1533 SF NEW RESTAURANT
3560 WEST TEMPLE AVE UNIT B+B1A (TO BE COMBINED)
POMONA, CA 91768

CHANGE OF USE RETAIL TO RESTAURANT

REVISION
072516

2/A1.5: SUSPENDED CEILING TILE DETAIL, NTS

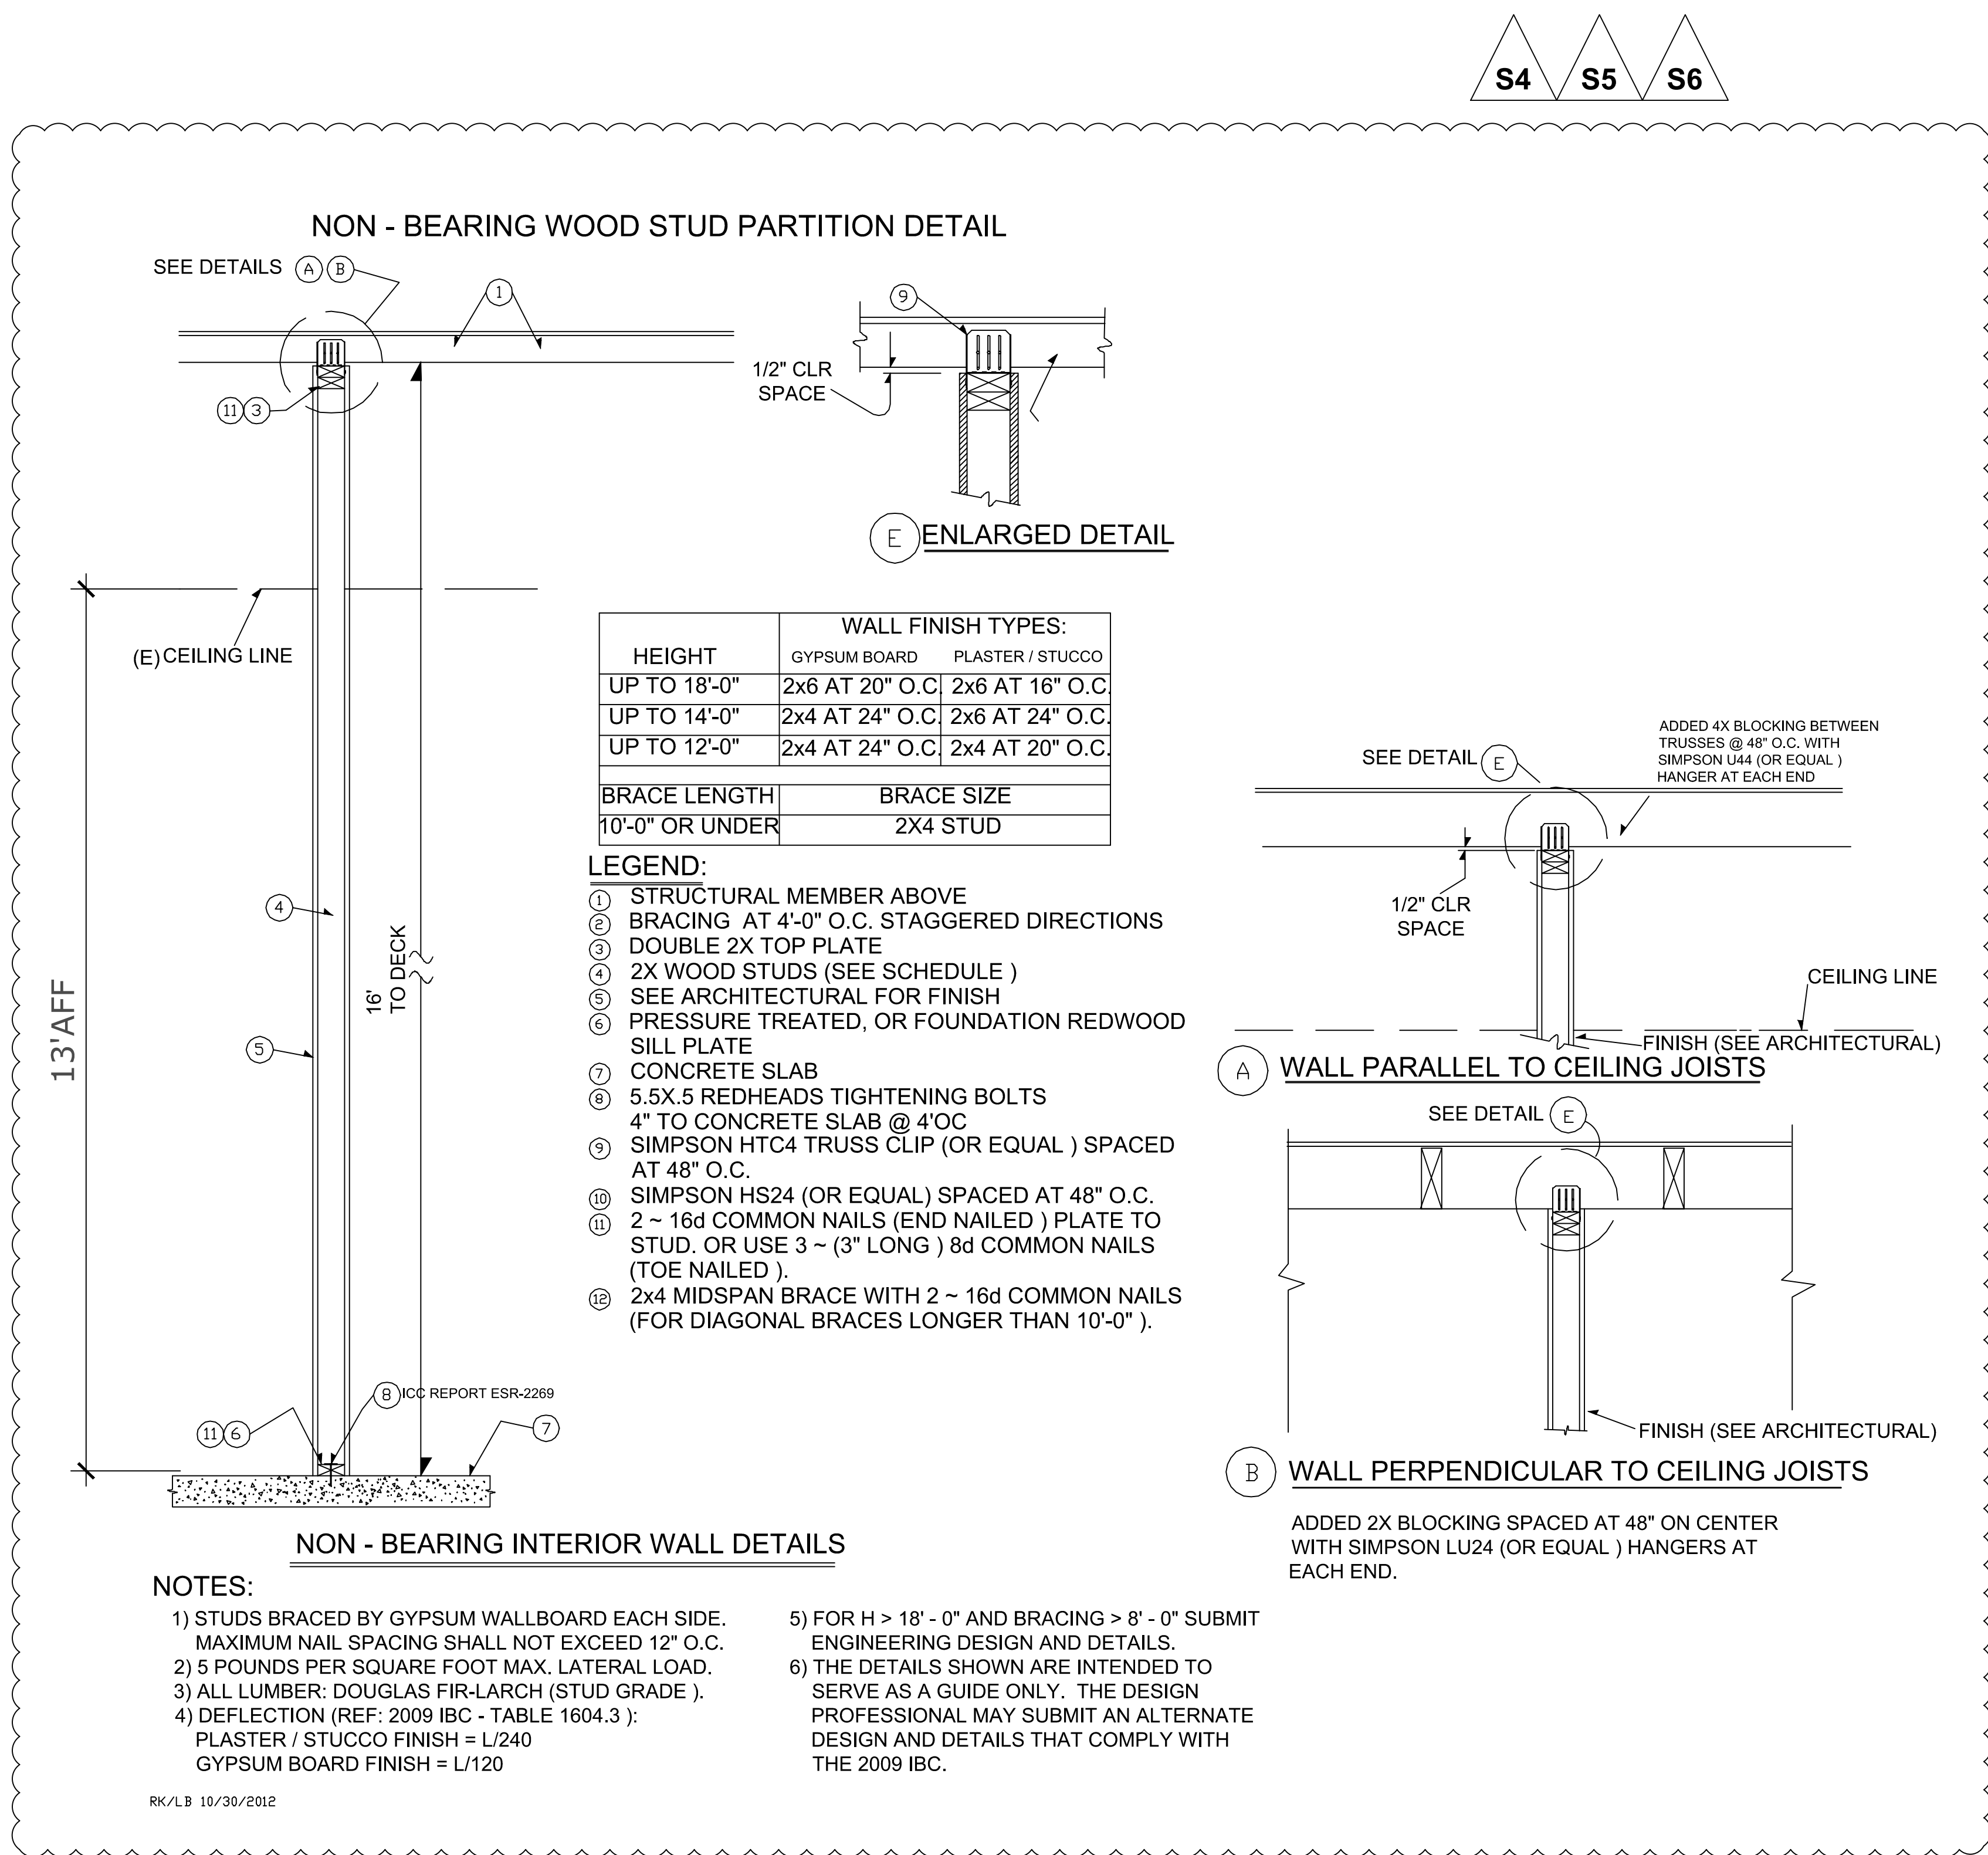
the associated Standard i.e. ASTM C635 and ASTM C 636, add details for heavy duty grid such as 2" closure angles, Berc seismic clips etc.

-  1. Indicate the height of all interior walls. Specify framing member sizes and spacing.
-  2. Interior wall framing and connections shall be designed to support a minimum lateral load of 5psf. (CBC 1607.14)
-  3. Provide seismic bracing details for partial height walls. Details shall indicate the size and spacing of bracing members and their connections.
-  4. Provide details for full height partition wall connections to the structure above, consider all framing conditions.
-  5. Provide details for wall base connections. Indicate the connector type, size and spacing.
-  6. Provide material specifications for light gauge metal framing. Specify the steel ASTM number and grade.
-  7. Provide details for metal stud headers, jambs, joists and braces. Specify all members and connector types, size, spacing etc.

- (4) #12 WIRES AT 90 DEG. APART AS LATERAL SUPPORTS AT 12'-0" IN EACH DIRECTION WITH THE FIRST POINT WITHIN 6'-0" OF ANY WALL. CONNECT TO MAIN RUNNERS WITHIN 2" OF CROSS RUNNERS AND TO THE STRUCTURE ABOVE AT AN ANGLE NOT TO EXCEED 45 DEG. FROM CEILING.
- #12 VERTICAL SUPPORT WIRES AT 4'-0" O.C. & 6" MAX. FROM ENDS. VERTICAL WIRES SHALL NOT BE OUT OF PLUMB BY MORE THAN 1 IN 6.
- CONTINUOUS WALL MOLD. ALLOWENCE SHALL BE MADE FOR LATERAL MOVEMENT OF THE SYSTEM. MAIN RUNNERS & CROSS RUNNERS MAY BE ATTACHED AT TWO ADJACENT WALLS W/ CLEARENCE BETWEEN WALL & RUNNERS MAINTAINED AT THE OTHER TWO WALLS.

- NOTES:
- VERTICAL SUPPORT SHALL BE PROVIDED AS REQUIRED IN CHAPTER 47 WITH THE ADDED REQUIREMENT THAT DISCONTINUOUS ENDS OF CROSS RUNNERS AND MAIN RUNNERS BE VERTICALLY SUPPORTED WITHIN 8" OF SUCH DISCONTINUITIES AS MAY OCCUR WHERE THE CEILING IS DISRUPTED BY A WALL.

- LIGHT FIXTURES AND AIR DIFFUSERS WEIGHING MORE THAN 20 LBS. BUT LESS THAN 56 LBS., SHALL HAVE TWO 12 GA. HANGERS CONNECTED FROM THE FIXTURE HOUSING TO CEILING SYSTEM HANGERS OR TO STRUCTURE ABOVE. ALL OTHER FIXTURES WEIGHING MORE THAN 56 LBS. SHALL BE SUPPORTED DIRECTLY FROM THE STRUCTURE ABOVE BY APPROVED HANGERS. CONNECTIONS SHALL BE DESIGNED FOR A LATERAL FORCE OF 100 PERCENT OF THE WEIGHT OF THE FIXTURES IN ADDITION TO THE PRESCRIBED VERTICAL LOADING.

- PROVIDE VERTICAL COMPRESSION STRUT AT 12'-0" O.C. MAX. EACH WAY, FROM CEILING GRID TO STRUCTURE ABOVE.
 - ALTERNATE MATERIALS FOR COMPRESSION STUTS MAY BE USED WITH JUSTIFICATION AND APPROVAL OF ARCHITECT AND LOCAL BUILDING OFFICIAL.
